CONSTRUCTION ADDENDUM: #01

PROJECT NAME: Brittany Park Window Replacement

ADDENDUM #1

Date: March 13, 2025

WINDOW LEGEND

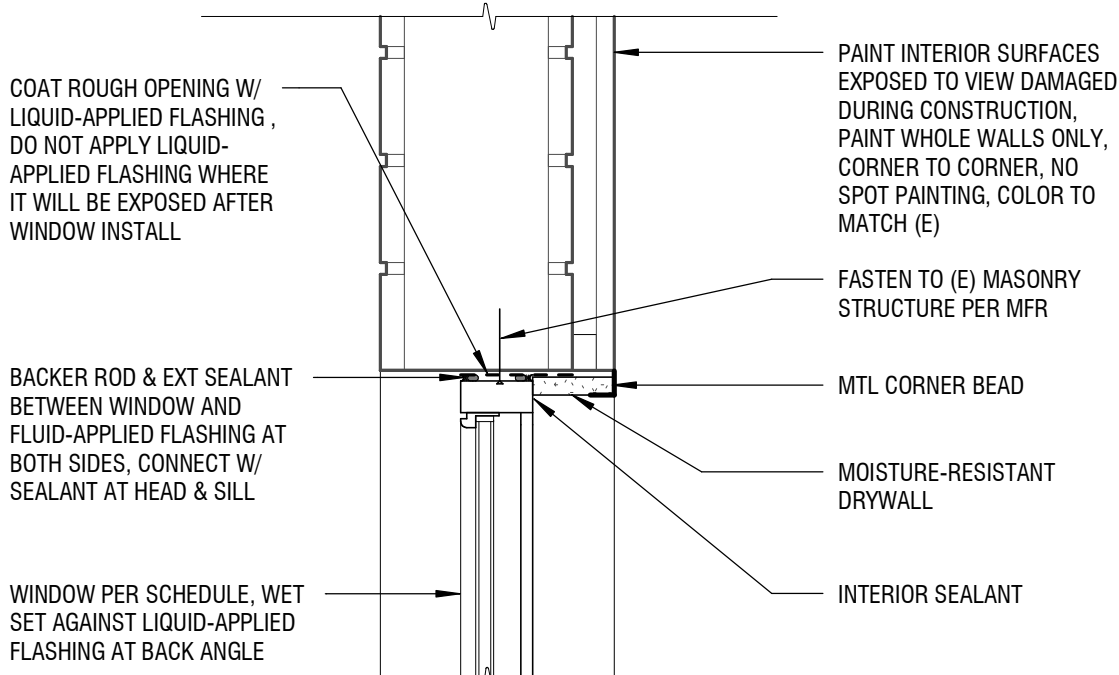
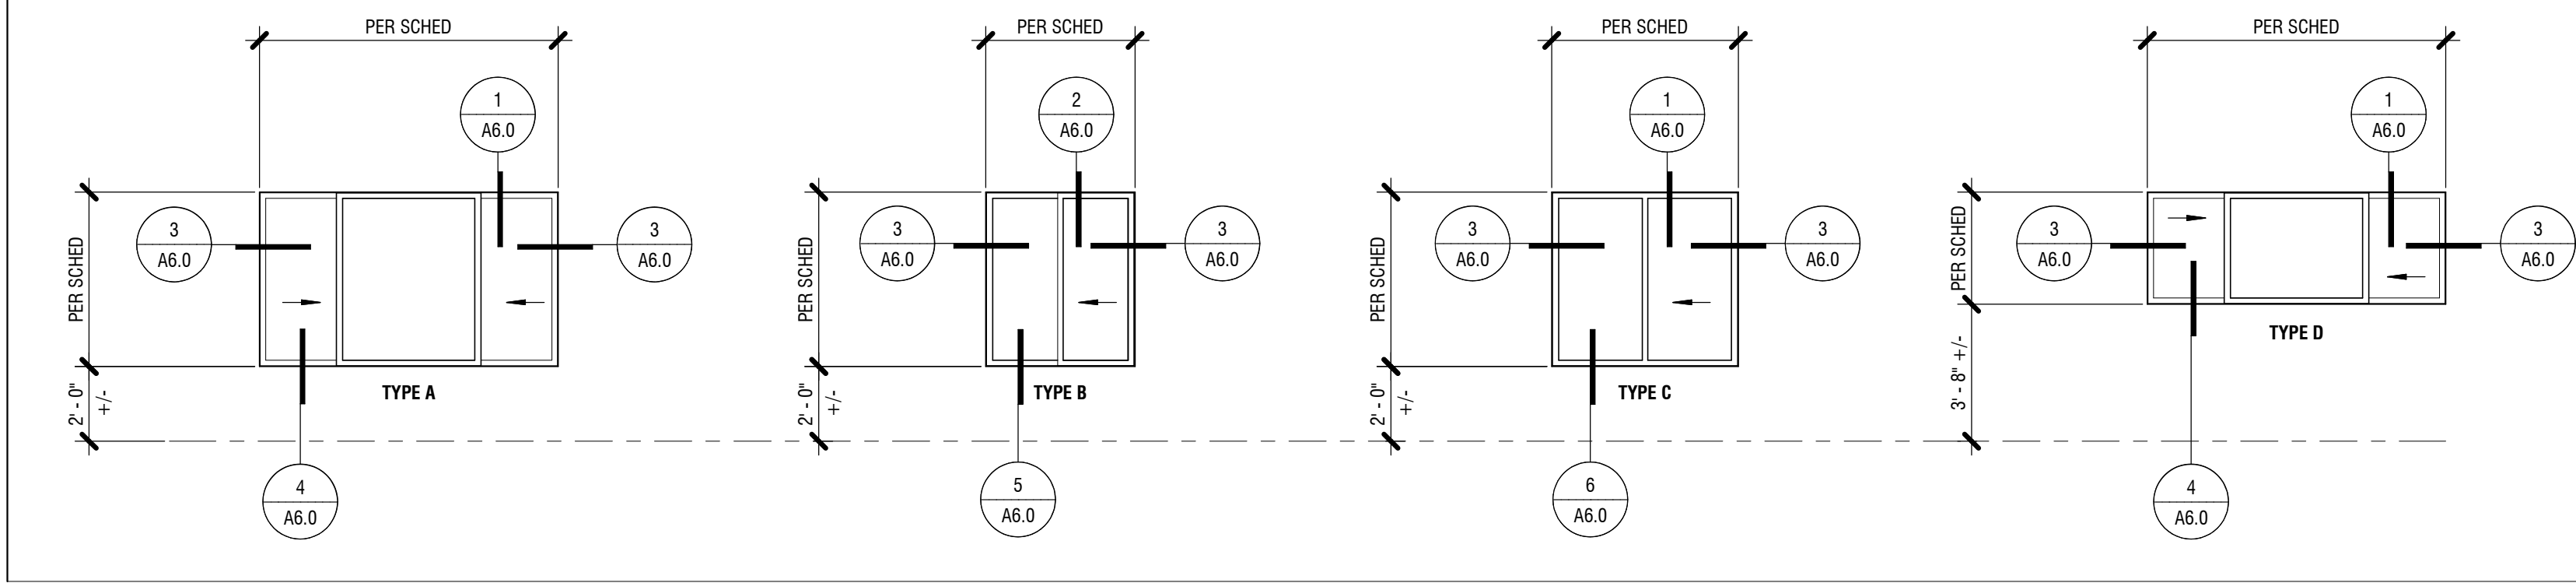
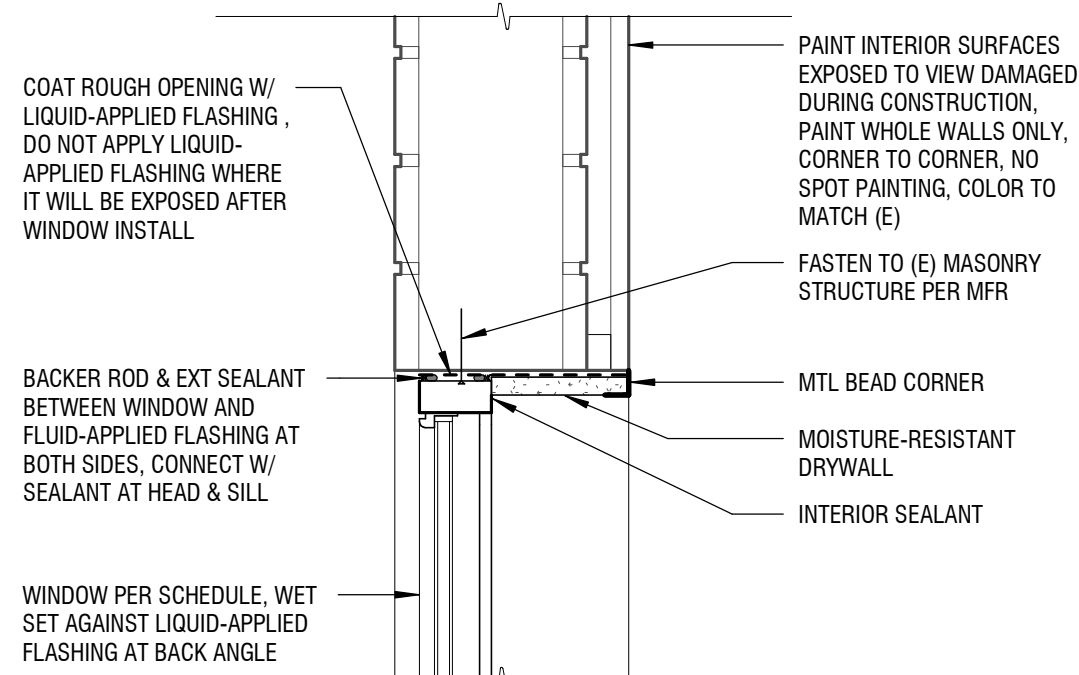
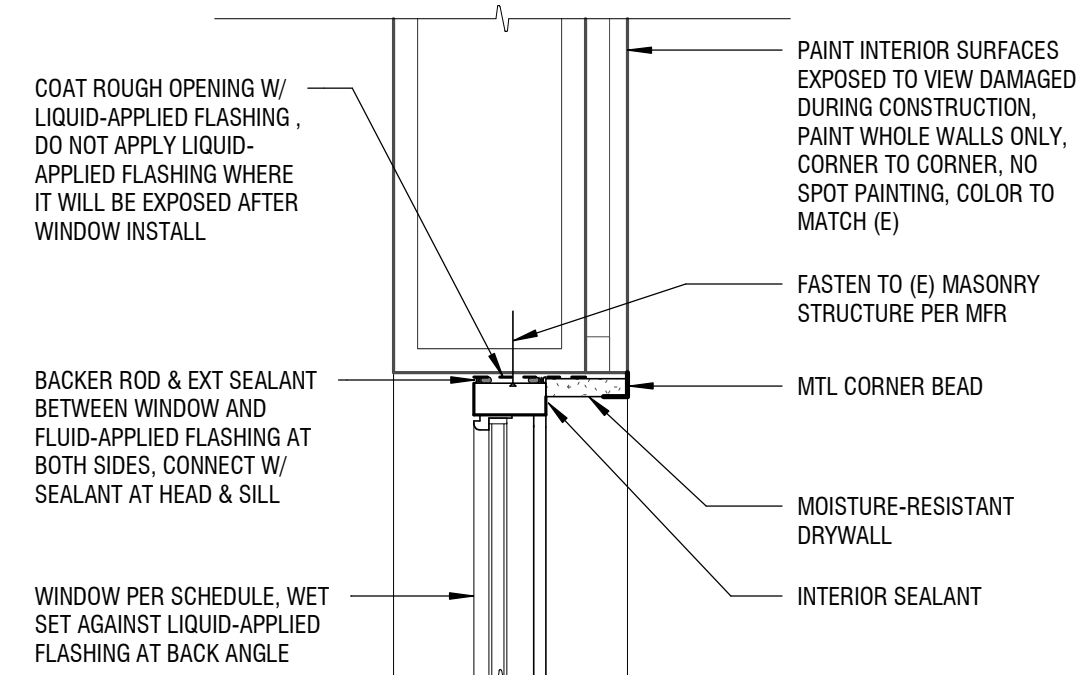
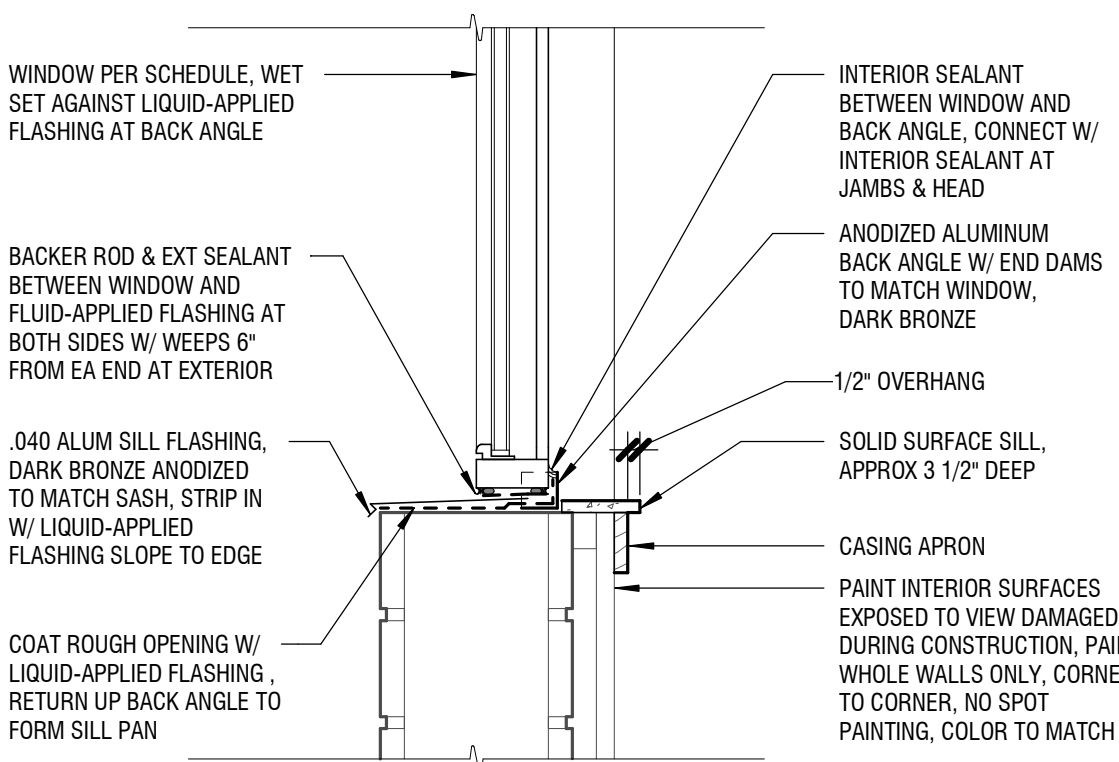
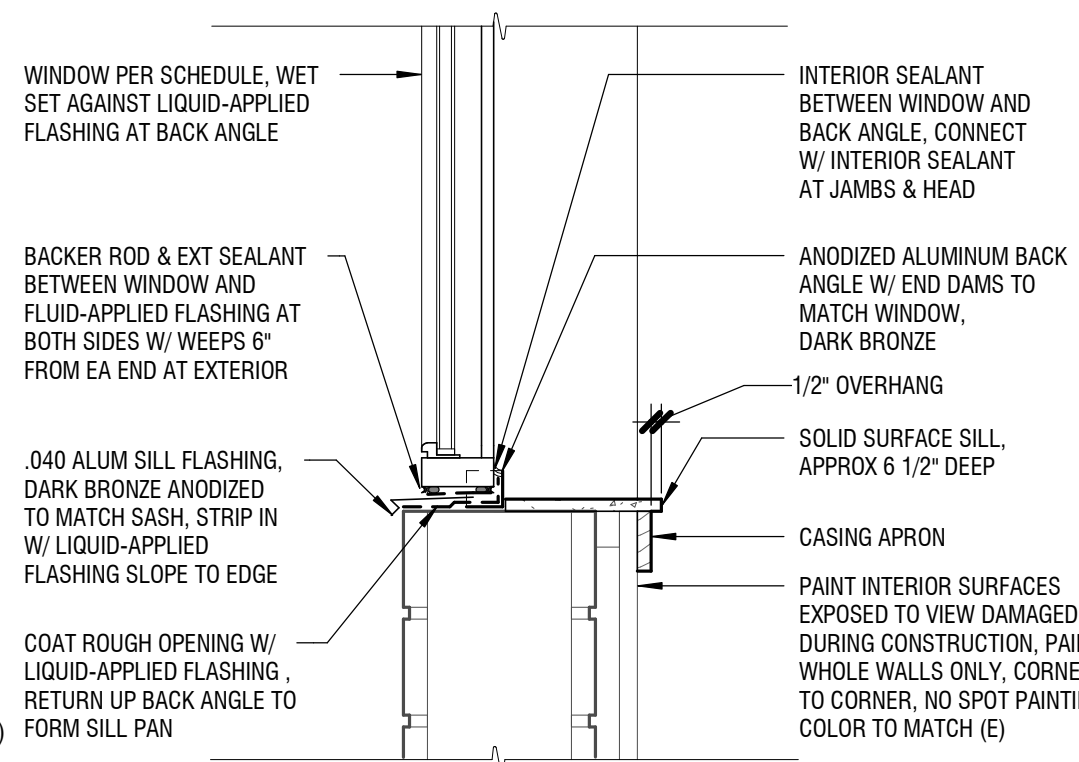
- a.* **Modify the** drawing Window Schedule per the attached revised drawing sheet A6.0 dated December 13, 2024.
